UNITED STATES PATENT AND TRADEMARK OFFICE

APPLICATION NO.	FILING DATE	FIRST NAMED INVENTOR	ATTORNEY DOCKET NO.	CONFIRMATION NO.
10/554,624	10/27/2005	Ryouichi Koga	P28729	7272

Office Action Summary	Application No. 10/554,624	Applicant(s) KOGA ET AL.	
	Examiner KAREN YOUNKINS	Art Unit 3751

DETAILED ACTION

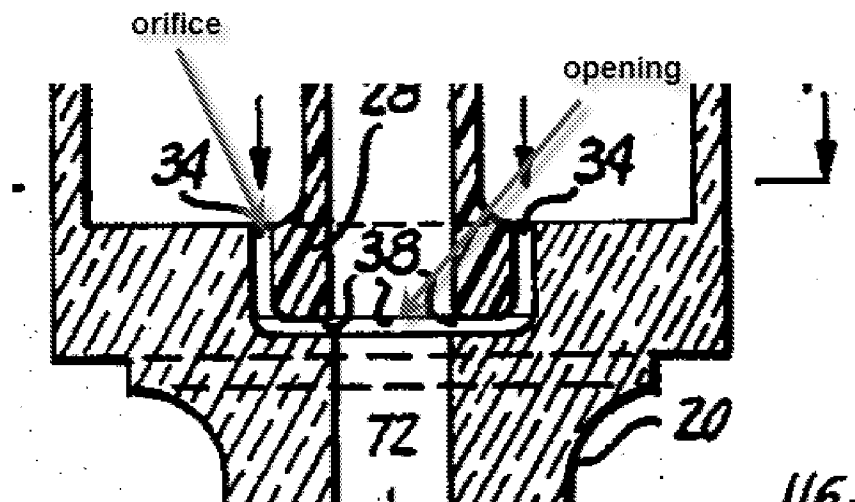
14. Regarding Claims 1 and 13, Gallo teaches a nozzle device comprising a spray hole 22, a pipe 30 forming a first flow path, a cover member (16/20) has the spray hole and surrounds the pipe. The cover member is cylindrical about 30 and is integrally formed. A front end, shown where reference character 20 points in figure 2, is closed and prevents washing water from exiting through the front end. There is a space (shown at 36) between an outer surface of the pipe and an inner peripheral surface of the cover member. This space forms a second flow path that introduces water to the

spray hole, such that the second flow path is configured to surround the outer surface of the pipe in a circumferential direction of the cover member (see figure 2).

15. Regarding Claim 2, a spray member (shown generally in the area around 34 and 28) has an orifice that is capable of merging washing water from the first and second flow paths as claimed.

16. Regarding Claim 3, the spray member has an 'internal space' with an opening at one end and an orifice at another end (see examiner annotated drawing above). The first flow path is capable of introducing water to the internal space via the opening, and the second flow path is capable of introducing water to the internal space from a peripheral surface of the spray member (see arrows in figure 2). The 'internal space' is an open area in the device. Therefore, there are infinitely many cross sectional areas of all sizes within the internal space, the internal space has a cross-sectional area that gradually or continuously decreases from opening to orifice. Similarly regarding Claim 10, there are infinitely many cross sectional areas of all sizes within the first flow path and the opening of the internal space.

17. Regarding Claims 4-5 and 7-9, (from opening to orifice) the internal space includes a first space having a first inner 'diameter' from said opening to said orifice, a second space having a second inner 'diameter' smaller than said first inner 'diameter', and a third space having a third inner 'diameter' smaller than said second inner

'diameter'. It is noted that the term 'diameter' renders the claim indefinite as discussed above and are treated as distances. The 'internal space' is an open area in the device. There are infinitely many distances of all sizes within the spray space. Liquid introduced from the second flow path is supplied to the second space, and all other spaces, as it moves through the device. The second space may have a cylindrical space (figure 2 is a cross sectional view), and the liquid introduced from the second flow path is supplied along an inner peripheral surface of the cylindrical space, and all other spaces, see flow of liquid arrows in figure 2.

18. Regarding Claim 11, the spray hole 22 is formed on a peripheral wall in the vicinity of a front end of the cover member (see figure 2) and is 'inserted' into the front end of the cover member as the 28 and 22 are not formed of the same piece, 28 insertably operates within 22/16.

21. Regarding Claim 15, the bottom end of the cover member (which is a ‘peripheral wall’) as shown in figure 2 is flat and in the vicinity of the front end. The spray hole is formed on this flat surface, see figure 2.

23. Regarding Claims 17-18, the connection between the protrusion at 28 (or ‘second flat portion’) and the corresponding side wall of 16 (around the opening at 34, or ‘first flat portion’) is a ‘positioner’ to the extent claimed, as the threads are capable of positioning a device. The orifice is ‘positioned relative’ to the spray hole as they are within the same device. The pipe is ‘inserted’ and positioned in such a way that the second flat portion and first flat portion are opposite. an See figure 2. Regarding Claim
